**CITY OF CHARLOTTESVILLE, VIRGINIA
CITY COUNCIL AGENDA**

Agenda Date:	February 22, 2022
Action Required:	Motion to Approve a Certificate of Appropriateness, or Motion to Deny a Certificate of Appropriateness
Presenter:	Jeff Werner, Preservation & Design Planner, Department of Neighborhood Development Services (NDS) Breck Gastinger, Chair, BAR
Staff Contacts:	Jeff Werner, Preservation & Design Planner, Department of NDS James Freas, Director, NDS
Title:	605 Preston Place - Appeal of BAR approval of a Certificate of Appropriateness (BAR 21-05-03)

City Staff Report in Response to the Appeal from the BAR's
Decision Granting a "CoA" for proposed apartment building at 605 Preston Place
(Application No. BAR 21-05-03)

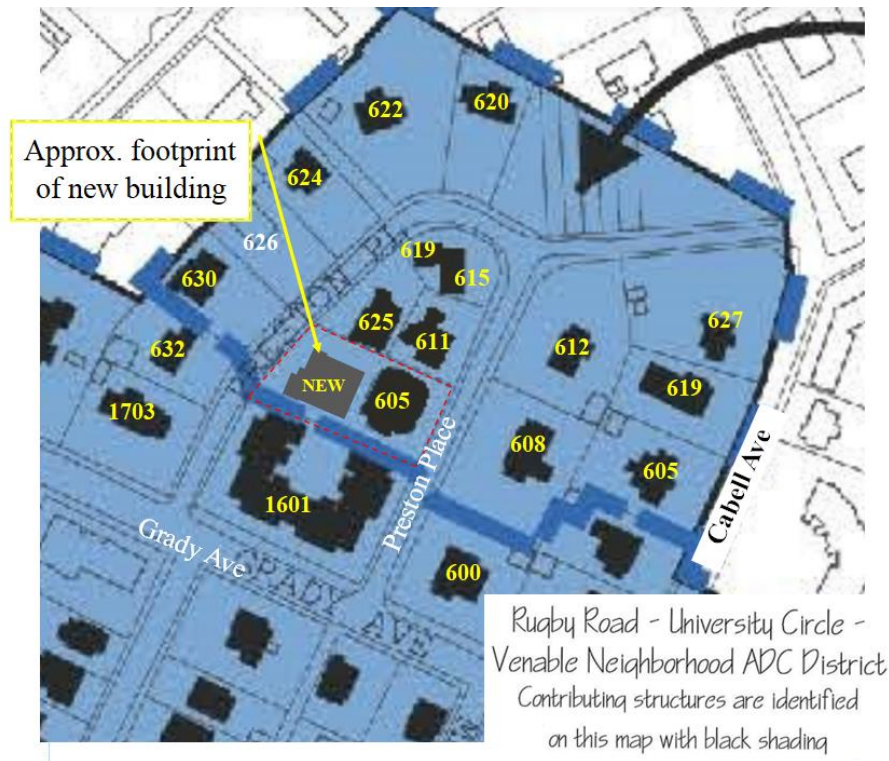
Staff reviewed the footprints of all the structures on Preston Place. (Excluding the adjacent Preston Court apartments that face Grady Avenue.) The average footprint is 2,085 square feet, ranging from 961 square feet to 4,404 square feet, with three buildings exceeding 3,500 square feet. The footprint of the new building is 3,523 square feet. The footprint of Wyndhurst is 4,404 square feet.

Within Sub-area C, the average footprint is approximately 2,291 square feet, ranging from 1,324 square feet to 4,404 square feet, with four buildings exceeding 3,500 square feet. The proposed building has a footprint of 3,523 square feet, which is within the range of nearby structures and those within Sub-area C.

Legally, the BAR cannot design a project or mandate any particular footprint; the BAR can only determine whether or not a particular development proposal, overall, is architecturally compatible with the ADC District, based on the recommendations of the design guidelines. As applied here, the BAR determined that a building with a footprint of 3,523 square feet is not inconsistent with the design guidelines.

Item 4. [*New structure will remove portion of Wyndhurst's west terrace.*]

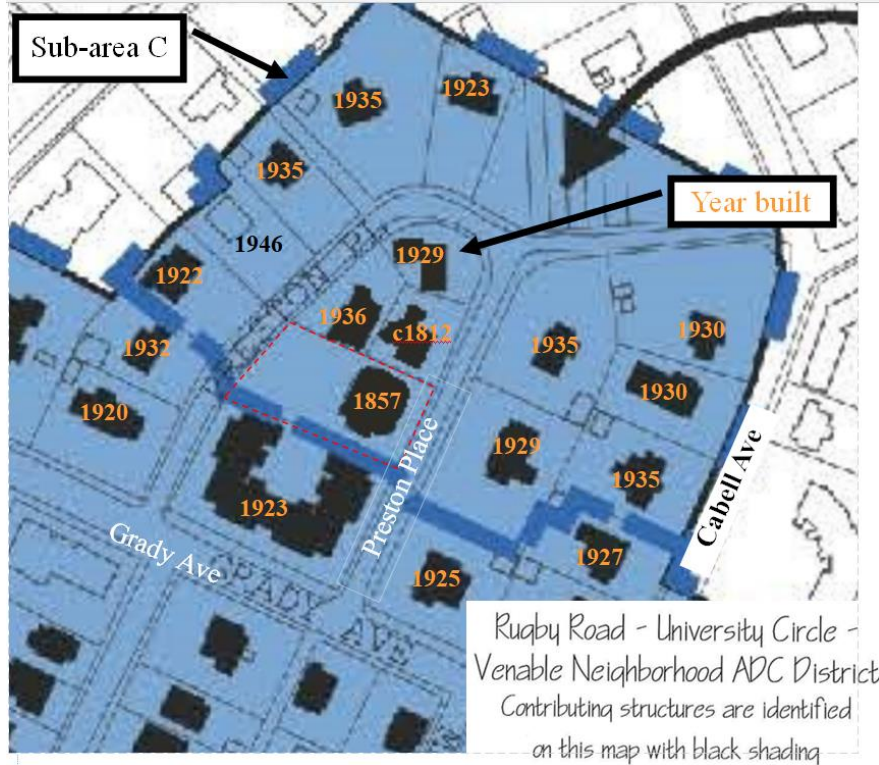
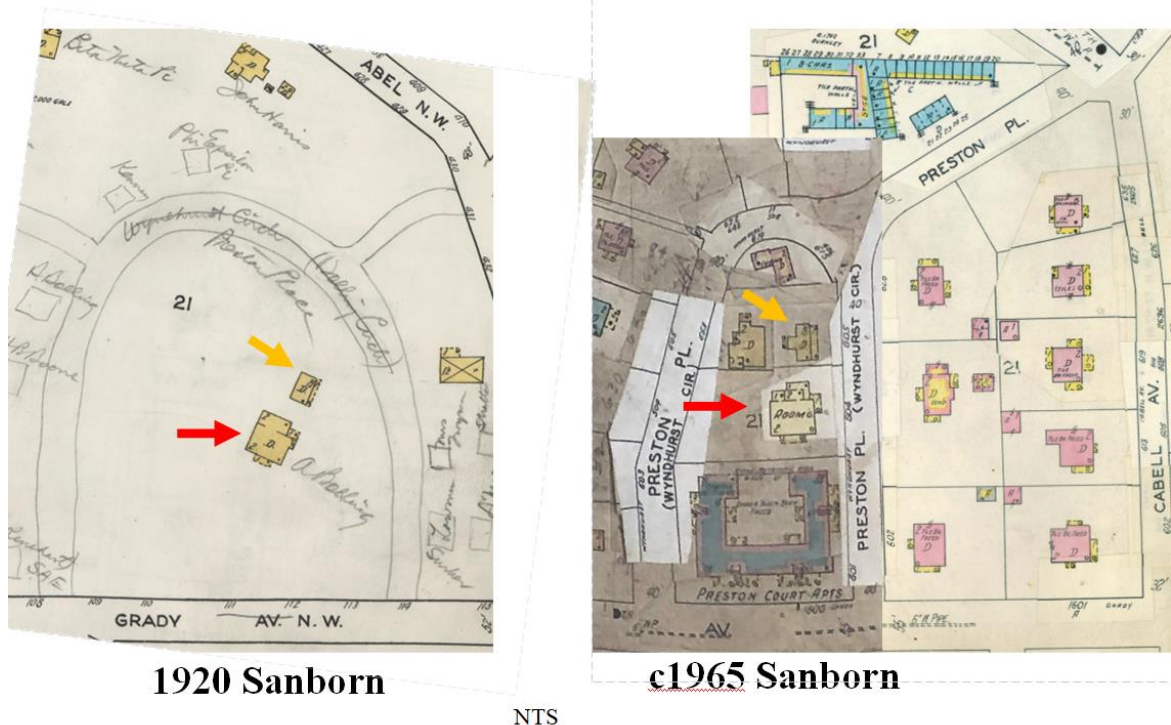
Appellant: We also point out that the proposed project intrudes into Wyndhurst's immediate environs, requiring the partial removal of its current 15-foot wide west terrace and all of the 4-foot grade transitioned by steps leading to the side yard. As such the proposed plan violates the ADC District Design Guidelines, Chapter 3, on infill construction in historic districts.

Staff Response: Alteration of the existing terrace and grade does not *violate* the ADC District Design Guidelines relative to recommendations for Residential Infill in Chapter 3 - *New Construction and Additions*, which state: *These buildings are new dwellings that are constructed on the occasional vacant lot within a block of existing historic houses. Setback, spacing, and general massing of the new dwelling are the most important criteria that should relate to the existing historic structures, along with residential roof and porch forms.* [Links to Design Guidelines in Attachment 3.]

The ADC District Design Guidelines, as a whole, recommend that a new structure respect and be compatible with the historic landscape and context of a district and nearby properties; however, the historic context of the Wyndhurst (that is, both the manor house itself and the original 102-acres surrounding the house) has been significantly altered. While it can be assumed that the grade immediately adjacent to house has not been changed and that the existing steps within the terrace are not recent or contemporary,

there is no documentation indicating the west terrace is an original element of the landscape.

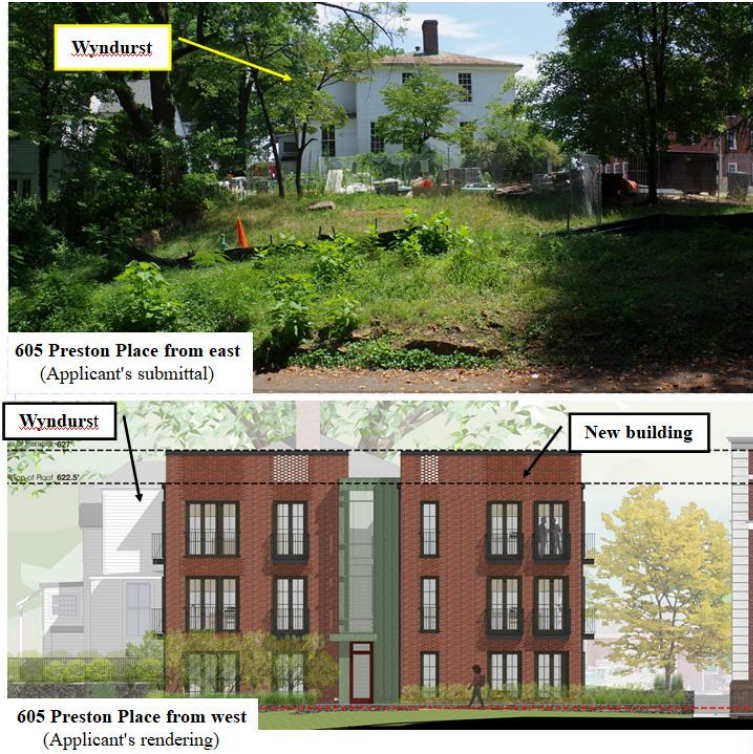
Staff Response: Regarding appellant claim that the new building *obscuring* Wyndhurst. By definition, this suggests the historic structure will no longer be visible and/or its historic setting and context will be difficult, if not impossible, to interpret.

Each of the applicant’s submittals included elevations, plans, and renderings illustrating the new building’s relationship to Wyndhurst and adjacent properties. (Links to the BAR submittals in Item 1.)

View from the west. Wyndhurst is located on the east edge of a rectangular, east-to-west oriented parcel. The new building will be on the west side of the parcel and will, to some extent, block the visibility of Wyndhurst from the west segment of Preston Place.

View from the east. Visibility from the public right of way of the south (original front), east, and north elevations of Wyndurst will not be altered by the new building.
